# Appendix I

## Seepage Meter Deployment Supplemental Information

**From:** [Ryan Barth](#)  
**To:** [Young, Hunter](#)  
**Cc:** [Peterson, Lance](#); [Azhar, Wardah](#); [Bob Wyatt](#); [Jen Mott](#)  
**Subject:** RE: US Moorings Second Phase PDIWP - proposed seepage meter timing  
**Date:** Wednesday, July 13, 2022 10:31:52 AM  
**Attachments:** [USM Project Area Second Phase PDI Seepage Mtr Rationale Supp Figs\\_071322.pdf](#)

**Subject:** US Moorings Second Phase PDIWP - proposed seepage meter timing

**Figure 1**  
 Site Plan Showing Upland Groundwater Monitoring Wells Used for Elevation Assessment  
 NW Natural Gasco Site

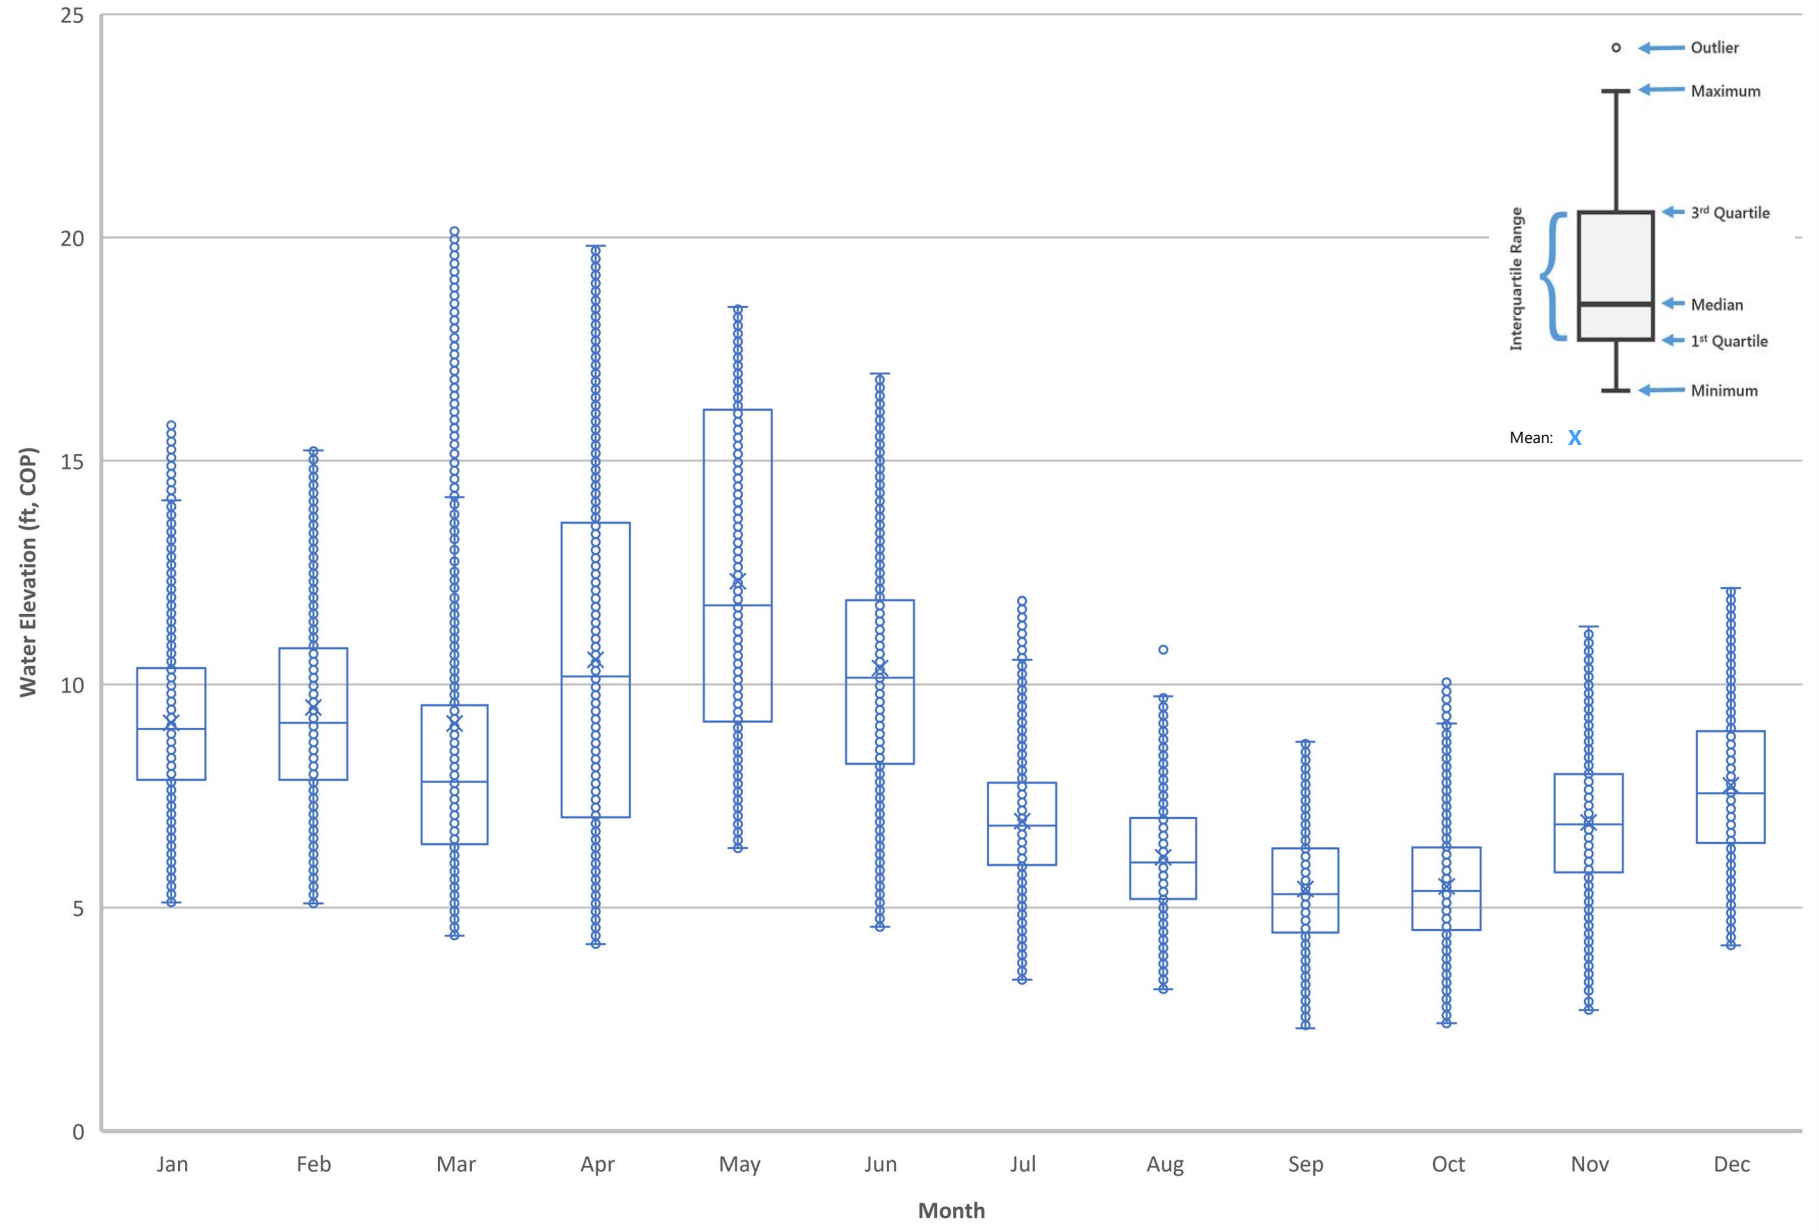
For consistency with what's being requested at other project areas, EPA asks that you provide an evaluation of groundwater levels in representative upland monitoring wells and Willamette River stage data to substantiate the targeted conditions for seepage meter deployments proposed in the Second Phase PDI Work Plan (i.e., late summer/early fall for the first round of deployment and spring for the second round). EPA recommends including a plot(s) of changes in groundwater elevations and river stage data over a period of at least one year. Note that the data to be used for this evaluation should be as localized to the US Moorings Project Area as possible. If groundwater data from nearby areas is used, justification should be provided for its relevance to the US Moorings Project Area. No resubmittal of the PDI Work Plan is necessary; the information can be transmitted to EPA via email. Please reach out with any questions.

As requested in your below email regarding our proposed seepage meter deployments in the US Moorings Project Area (Project Area) as part of our *First Phase Pre-Design Investigation Data Summary Report and Second Phase Pre-Design Investigation Work Plan* (Work Plan), this email and attached figures provide an evaluation of groundwater levels in representative upland monitoring wells and Willamette River elevation data to substantiate the targeted conditions for offshore seepage meter deployments proposed in the Work Plan (i.e., fall for the first round of deployment during low river elevations and spring for the second round of deployments during high river elevations).

As described in the U.S. Environmental Protection Agency's (EPA's) *Remedial Design Guidelines and Considerations – Portland Harbor Superfund Site, Portland, Oregon* (2021), porewater and seepage meter deployments should be conducted “at a time of the year when groundwater flux into the river is at its maximum.” This occurs when the river elevations are lowest relative to upland groundwater in hydraulic connection with the locations of the proposed seepage meter deployments (i.e., during the fall period). In addition, NW Natural proposes to collect offshore seepage data during high river elevations to understand the variability of seepage relative to groundwater elevations. To evaluate when these hydraulic conditions occur within the Project Area, Anchor QEA, LLC, evaluated the nearshore groundwater elevations in the Fill Water-Bearing Zone (WBZ) on the northeast portion of the Gasco property closest to the US Moorings property because there are no monitoring wells on the US Moorings property. We compared the river elevations over a 5-year period (2017 through 2021) to the measured observation well elevations at OW-7-17, OW-8-15, OW-9-25, and OW-10F (see attached Figure 1). These Fill WBZ observation wells are not affected by pumping from the Gasco property hydraulic control and containment (HC&C) system and are directly upriver from the US Moorings property, so they are representative of the groundwater/surface water interactions in the Project Area. Figures 3 to 7 depict a comparison of the mean measured river elevations during the 5-year period, starting with OW-10F, which is closest to the US Moorings property, and extending to OW-7-17 slightly farther upriver from the property. This multiyear comparison documents that the river elevations are lowest and highest relative to nearshore groundwater elevations in September/October and March/April, respectively. Therefore, consistent with the deployment period identified in the Work Plan, NW Natural proposes to deploy the seepage meters during these two periods.
